STAFF REPORT

PLANNING & ZONING COMMISSION

1. CERTIFICATE OF APPROPRIATENESS

Applicant: Mathew Althouse
Location: 26 W Olentangy Street
Existing Zoning: Downtown Business District (DB)
Request: To review a proposal to revert back to the previously approved architecture and site plan for a bar/tavern.

1
A2.1 EXTERIOR ELEVATION - SOUTH
1/4" = 1'-0"

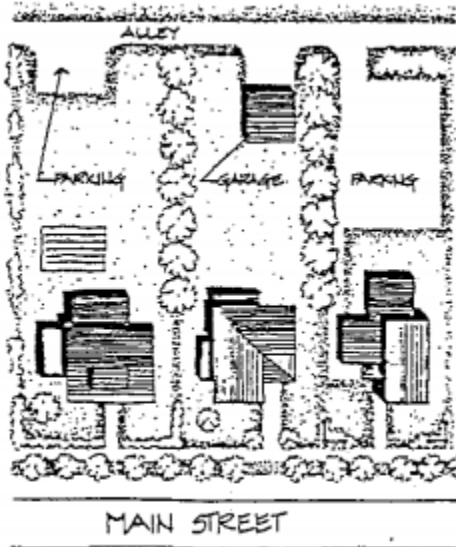
- The proposed project is generally in line with the architectural style recommended in the PAG.
 - The proposed building is in the general Midwestern rural aesthetic.
 - The existing building was added onto over time and although the building does not fit perfectly into the styles of the historic district, Staff feels that the improvement to the existing building using historic colors and materials. Furthermore, the building as it stands, has historic value as it is one of the older building in the downtown core.

- The proposed project is in line with site considerations of the PAG.
 - Access to rear yard parking lots and storage or garage buildings should be from alleys whenever possible.
 - The proposal has designed their parking lot in this fashion.
 - Commercial lots should be paved with asphalt, brick, concrete, or tar and chips as required in the Powell Zoning Code.
 - Renderings show an asphalt type of pavement.

RIBBON WINDOW

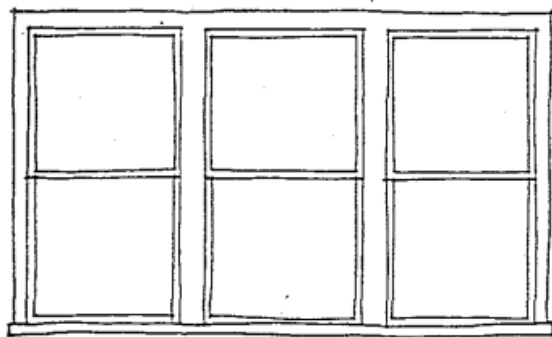
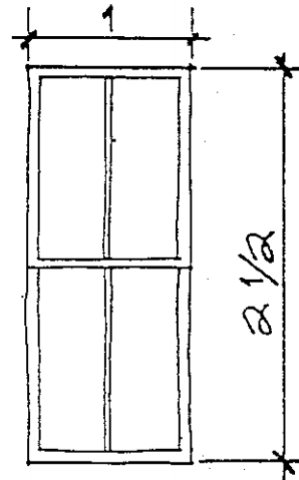
- The proposed project is somewhat in line with the PAG.
 - The front elevation of the proposal displays the Ribbon style, one of the three historically correct window styles with a 2-over-2 pattern. (Page 48)
 - Further examination by the Powell Architectural Advisor and HDAC is needed to determine whether the panels above the front windows are appropriate.
